# CARLSBAD DESALINATION PLANT

## REVISED ENTRAINMENT ANALYSIS FOR BRINE DISCHARGE OPTIONS

**ATTACHMENT 1: APPENDIX FFF – REVIEW OF  
THE CALCULATION METHODS USED IN THE  
CARLSBAD DESALINATION PLANT  
ENTRAINMENT ANALYSIS AND FINAL  
SCIENCE ADVISORY PANEL REPORT DATED  
SEPTEMBER 15, 2018.**

**Independent review: TOPICS FOR NEUTRAL THIRD PARTY REVIEW IN SUPPORT OF  
THE REISSUANCE OF THE NATIONAL POLLUTANT DISCHARGE  
ELIMINATION SYSTEM (NPDES) PERMIT FOR THE CARLSBAD  
DESALINATION PLANT**

**Figure 1: Relationship between Impingement and MGD for 50 “ordinary” events.**

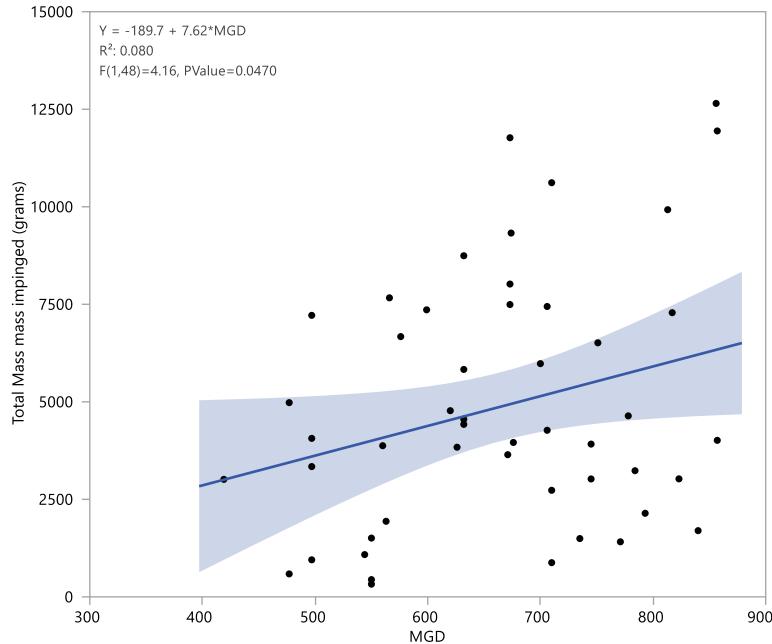
The relationship depicted in figure 1, as expected, shows an increase in impingement as MGD increases. However the relationship is much weaker than expected. This is due to the high level of simple temporal variability in impingement unrelated to flow (e.g. pulses of individuals near the intake structure). Adding the two extraordinarily high impingement events corrupts the relationship entirely (see figure 2 below).

Including all 52 events causes the relationship to shift from positive (figure 1) to negative (figure 2). Note that the relationship is significant in figure 1 ( $p = 0.047$ ) but not in figure 2 ( $p=0.2871$ ). It is clear that the inclusion of all data corrupts the relationship between MGD and impingement. Nordby recognized this and derived an estimate of impingement related to CDP MGD that was based on a hybrid approach. The 50 ordinary events were calibrated by the MGD ratio noted above and the 2 extraordinary events were not. This lead to an estimated daily impingement rate of 4.7 kg per day (=10.36 lbs per day). For comparison, calibrating all the data and using the relationship shown in figure 2, the estimate for 304 MGD would have been 14.03 kg per day (at the 50% confidence limit).
